SUBJECT: Forwards updated response to deviations noted in EOPs Insp  
 Rept 50-397/91-27, satisfying commitment made in 940425  
 response to Insp Rept 50-397/94-01.

Subject: **WNP-2, OPERATING LICENSE NPF-21  
NRC INSPECTION OF WNP-2 EMERGENCY OPERATING PROCEDURES  
(NRC INSPECTION REPORTS NO. 91-27 AND 94-01)**

This letter satisfies the commitment made in Reference 2 to NRC Inspection Report 94-01 to update our response to NRC Inspection Report 91-27 regarding Emergency Operation Procedures (EOP) deviations from the Boiling Water Reactor Owners Group (BWROG) Emergency Procedure Guidelines (EPGs), Rev. 4.

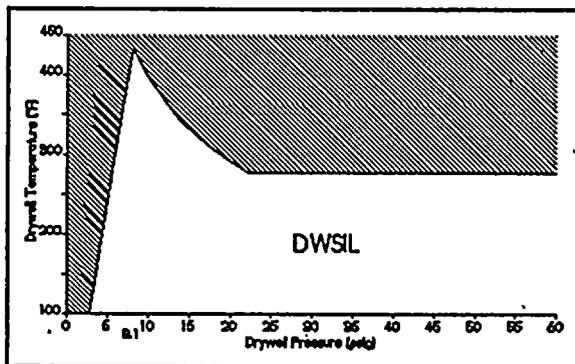
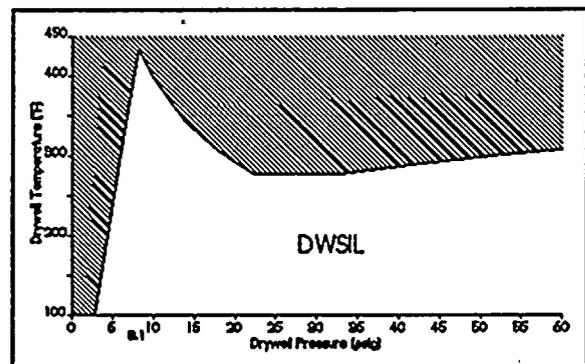
The BWROG EPG Appendix C Drywell Spray Initiation Limit (DSIL) worksheet (WS-3) resulted in a curve for WNP-2 which prohibits the initiation of drywell sprays under drywell pressure-temperature conditions at which the WNP-2 licensing basis assumes their use. The DSIL calculation was modified to overcome this conflict with the Design Basis. WNP-2 also intends to modify the curve further. The DSIL curve resulting from this additional modification is addressed as the "proposed" WNP-2 DSIL curve in the following discussions. (Note: Neither the Basis nor the intent of the EPG was violated in taking this deviation.)

Based on this position of the EPC, WNP-2 intends to adopt the (plant-specific) DSIL curve identified as the "Proposed" WNP-2 DSIL Curve in the figure in Section O.6, following formal documentation of the supporting WNP-2 calculation. The deviations and the justifications for the deviations involved in developing this curve are presented in section O.6 below.

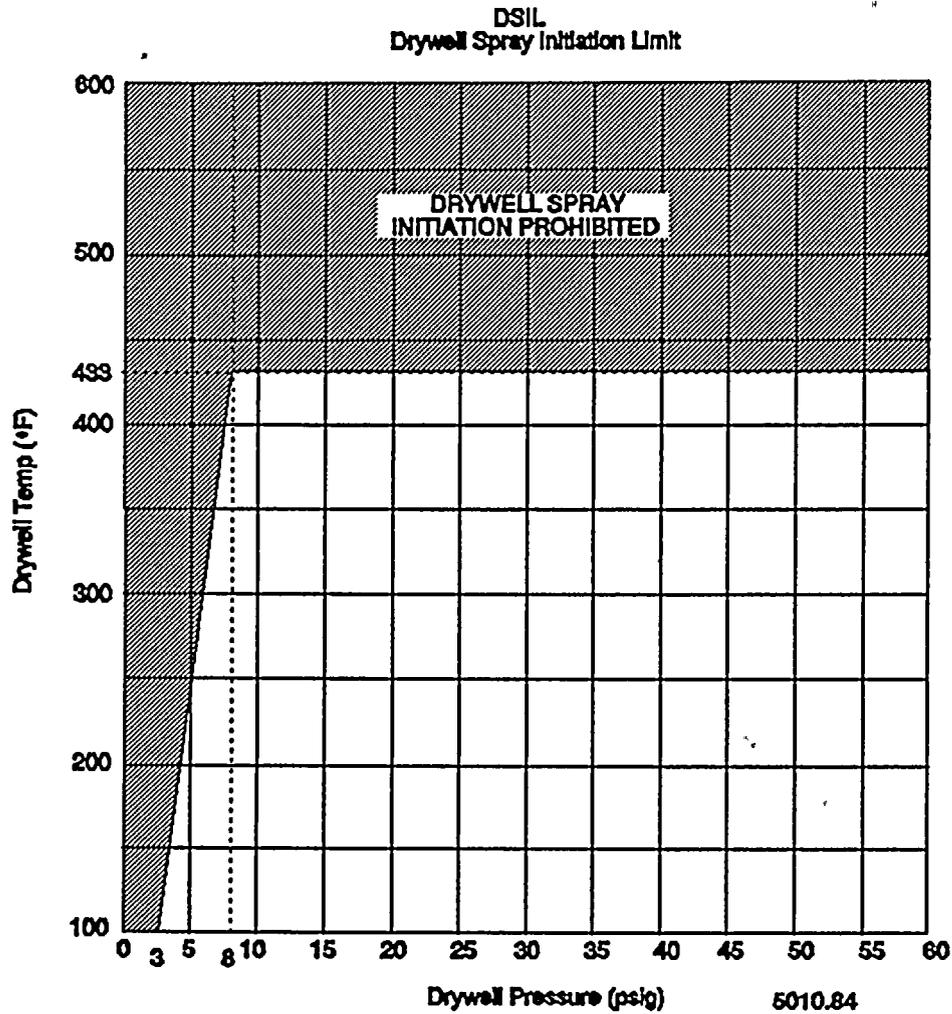
The BWROG methodology defines a variable "T<sub>dw-min</sub>(P<sub>dw</sub>)" which is a line describing the drywell temperature as a function of pressure assuming that all the nitrogen originally in the containment has been transferred to the drywell and is at 0.0% humidity. This line provides an upper bound to the pressure in the drywell for all isolated containment situations if the drywell is completely dry.

For cases in which the humidity is 100%, a line may be drawn on the same graph which defines the minimum possible pressure in the containment as a function of temperature, by assuming that all of the nitrogen has instead been transferred to the wetwell. This line is simply the saturation line for water vapor.

The figure shows these two curves as well as the DSIL which is developed from the generic guidelines. On the right side of the curve is an area where the water vapor saturation line is above the DSIL. This is also the region where WNP-2 licensing basis calculations have assumed that the containment sprays would be used in a LOCA type accident.
